Decision Report

Refresh Vaucluse and Diamond
Bay Project

December 2020

Figure 1 - Servicing catchments of the existing ocean outfalls at Vaucluse and Diamond Bay

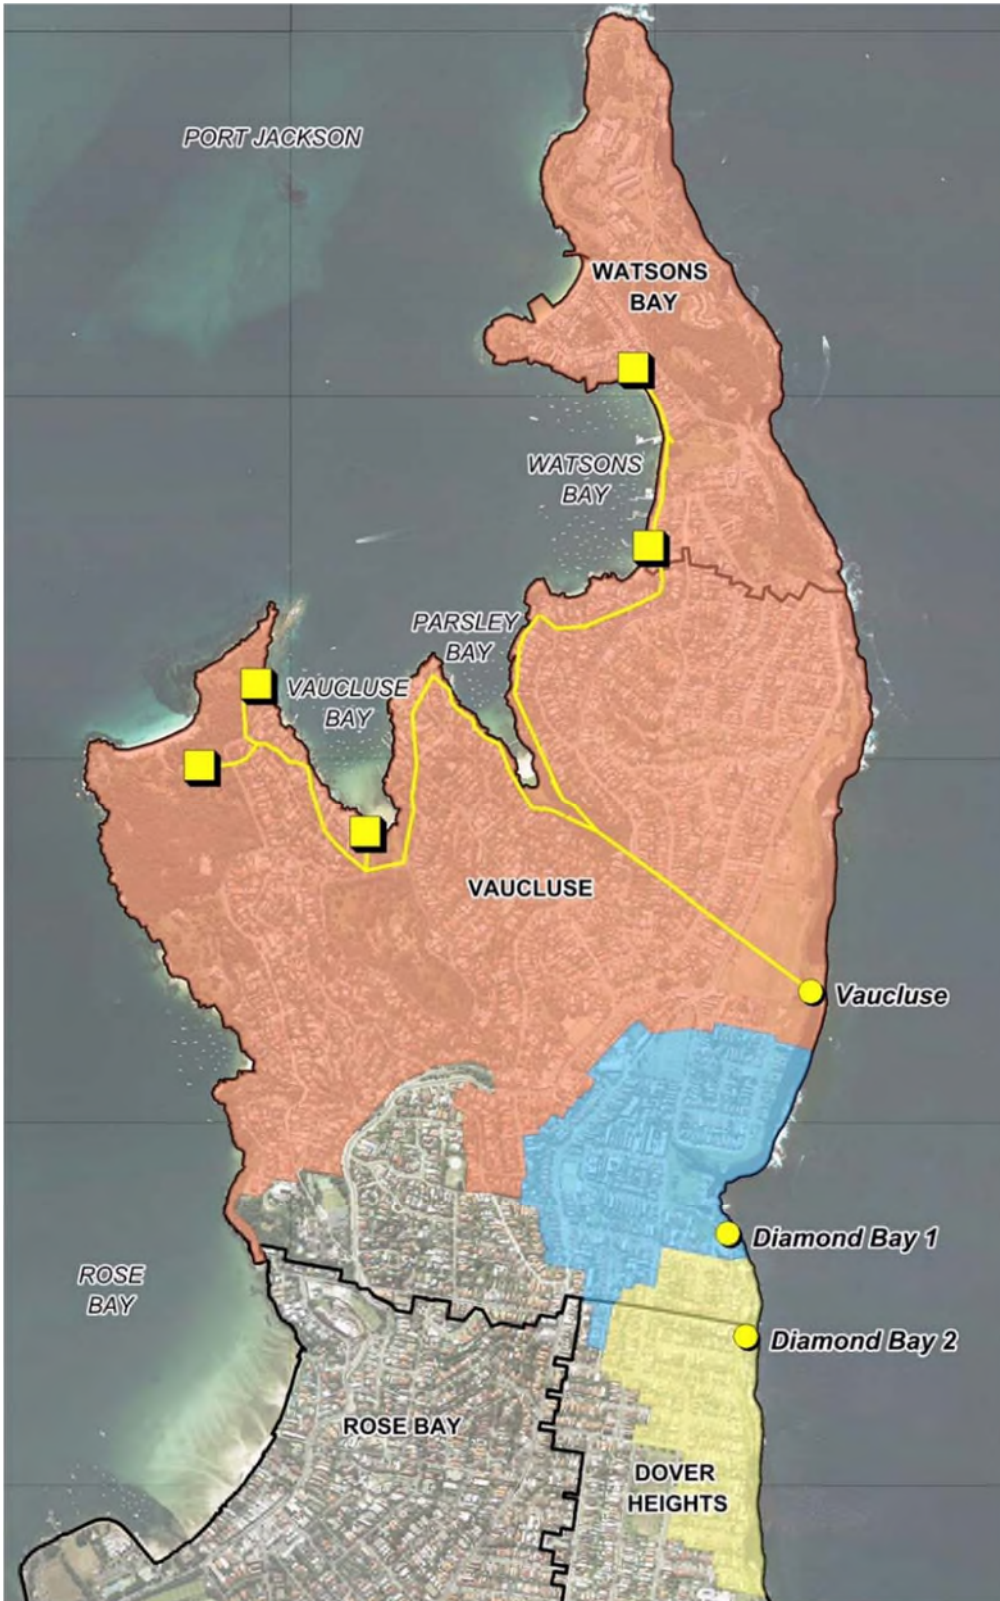
Question regarding the current location of discharge of wastewater in Vaucluse and Diamond Bay, and what catchments the outfalls are servicing. Also concern regarding potential discharge into Parsley Bay and why this area was chosen for the location of the wastewater pump station.

The REF does not show the catchment in which are currently serviced by the outfalls that will be redirected.

There are currently three ocean outfalls located in Vaucluse, Diamond Bay and Dover Heights that discharge untreated wastewater at the cliff face. Figure 1 shows the location and current catchments serviced by each of the three outfalls. It is worth noting that sections of Rose Bay and Dover Heights (non-coloured area in Figure 1) are already connected to the Bondi WWTP.

In order to collect the wastewater from the Vaucluse catchment, the existing large wastewater infrastructure shown in yellow in Figure 1 needs to be intercepted. The existing network has five pumping stations and gravity pipes which transfer flows to Parsley Bay. The Vaucluse Ocean Outfall Sewer (VOOS) starts from Parsley and terminates at the cliff face of the Christenson Park. The infrastructure converges near Parsley Bay before it flows via the ocean outfall pipe. As such, Parsley Bay is the ideal location to divert the flow away from the ocean outfall as it requires minimal infrastructure and disturbance to the community.

There will be no planned discharge of wastewater into Parsley Bay. All wet weather overflows will be diverted to the existing Vaucluse outfall via the VOOS as per the current operation.

The yellow boxes in Figure 1 below show the locations of existing wastewater pump stations at Watsons Bay and Vaucluse Bay.
